Access Compliance Report

Public Rights-of-Way

(Curb Ramps)

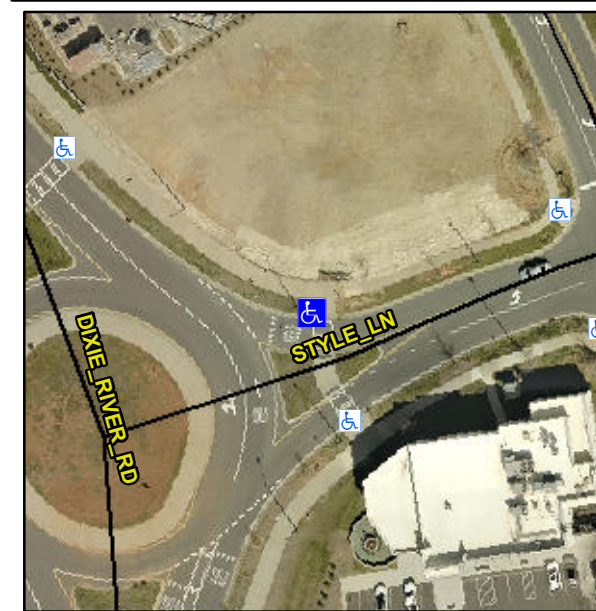
Not Found, R304.5.3

Compliance	Description	Data	Compliance	Description	Data
N/A	Ramp Length (in)	94.0	Yes	Ramp Slope (%)	6.1
Yes	Ramp Width (in)	48.0	No	Ramp XSlope (%)	3.1
N/A	Flare Type LT	N/A	N/A	Flare Type RT	N/A
N/A	Flare Slope LT (%)	N/A	N/A	Flare Slope RT (%)	N/A
N/A	Flare Traversable LT?	N/A	N/A	Flare Traversable RT?	N/A
N/A	Landing Length (in)	N/A	N/A	DWS Provided?	N/A
N/A	Landing Width (in)	N/A	N/A	DWS Contrast?	N/A
N/A	Landing Slope (%)	N/A	N/A	DWS Length (in)	N/A
N/A	Landing X Slope (%)	N/A	N/A	DWS Full Width?	N/A
N/A	Landing Curb? (Y/N)	N/A	N/A	DWS Offset (in)	N/A
N/A	Shared Landing?	N/A			
N/A	Gutter Ponding?	N/A	N/A	Gutter Slope (%)	N/A
N/A	Gutter Lip Ht (in)	N/A	N/A	Gutter X Slope (%)	N/A
N/A	Painted X Walk1?	Yes	N/A	Painted X Walk2?	N/A
	X Walk 1 Direction	To S		X Walk 2 Direction	N/A
N/A	X Walk 1 Width (in)	113.0	N/A	X Walk 2 Width (in)	N/A
	X Walk 1 Slope (%)	1.5		X Walk 2 Slope (%)	N/A
	X Walk 1 X Slope (%)	3.1		X Walk 2 X Slope (%)	N/A

Remove & Replace Entire Ramp.
